How to Recognize the New Coils

Aluminum Coils & Fan Coils:
Quality.
Performance.
Easier Installation.

Part No. 401-12-0150-00 Printed 4/14

| COIL MODEL NUMBER IDENTIFICATION GUIDE | | | | | | | | | | | |

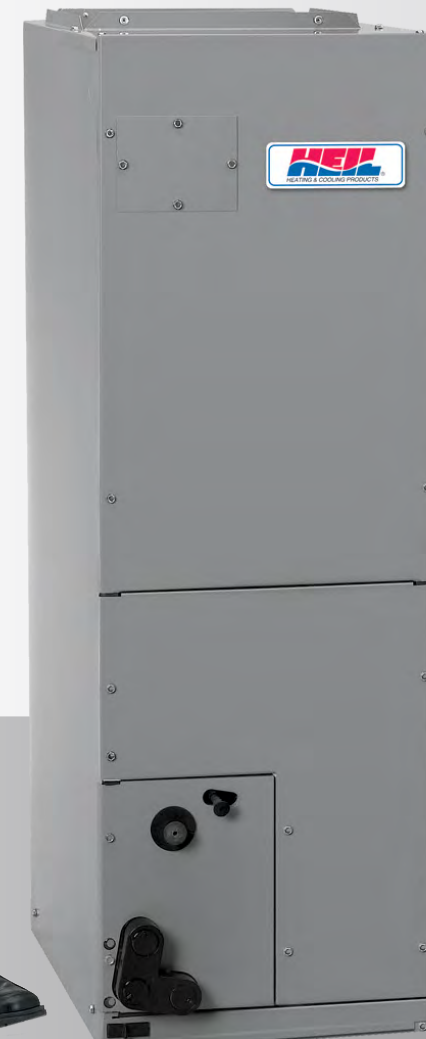
- The packaging has a blue label indicating they are aluminum.
- On evaporator coils, the eighth digit of the model number will change to an “L” for “aluminum” (instead of a “C” for “copper” or a “T” for “tin-plated”).
- On fan coils, the eleventh digit will change to an “L” for “aluminum.”
